Access Compliance Report

Public Rights-of-Way

(Curb Ramps)

Intersection ID: N/A	Main Street: CLANTON_RD	Cross Street: I-77_TO_CLANTON_RD	Location: SW
ADA ID: 4EB9386A0470	Ramp Type: Perp	Initial Pass/Fail: Fail	Overall Compliance: No
		Severity Score: 8.75

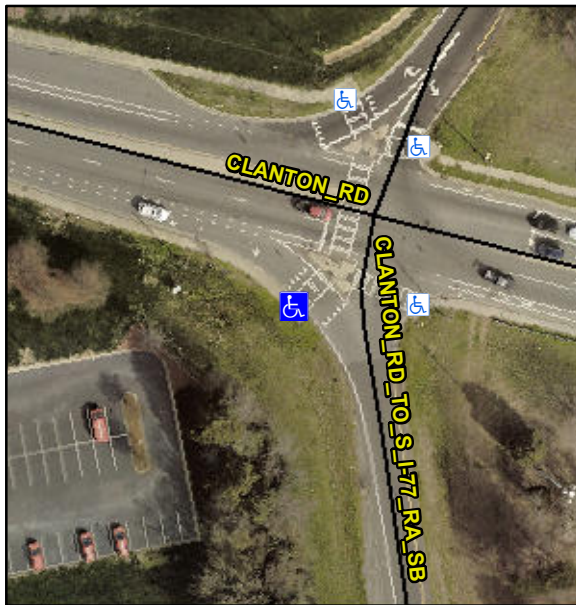
Not Found, R304.5.1

Compliance	Description	Data	Compliance	Description	Data
N/A	Ramp Length (in)	27.5	Yes	Ramp Slope (%)	5.3
No	Ramp Width (in)	47.0	Yes	Ramp XSlope (%)	0.2
N/A	Flare Type LT	N/A	N/A	Flare Type RT	N/A
N/A	Flare Slope LT (%)	N/A	N/A	Flare Slope RT (%)	N/A
N/A	Flare Traversable LT?	N/A	N/A	Flare Traversable RT?	N/A
N/A	Landing Length (in)	N/A	N/A	DWS Provided?	N/A
N/A	Landing Width (in)	N/A	N/A	DWS Contrast?	N/A
N/A	Landing Slope (%)	N/A	N/A	DWS Length (in)	N/A
N/A	Landing X Slope (%)	N/A	N/A	DWS Full Width?	N/A
N/A	Landing Curb? (Y/N)	N/A	N/A	DWS Offset (in)	N/A
N/A	Shared Landing?	N/A			
N/A	Gutter Ponding?	N/A	N/A	Gutter Slope (%)	N/A
N/A	Gutter Lip Ht (in)	N/A	N/A	Gutter X Slope (%)	N/A
N/A	Painted X Walk1?	Yes	N/A	Painted X Walk2?	N/A
	X Walk 1 Direction	To NE		X Walk 2 Direction	N/A
N/A	X Walk 1 Width (in)	110.5	N/A	X Walk 2 Width (in)	N/A
	X Walk 1 Slope (%)	4.4		X Walk 2 Slope (%)	N/A
	X Walk 1 X Slope (%)	0.7		X Walk 2 X Slope (%)	N/A

Remove & Replace Entire Ramp.
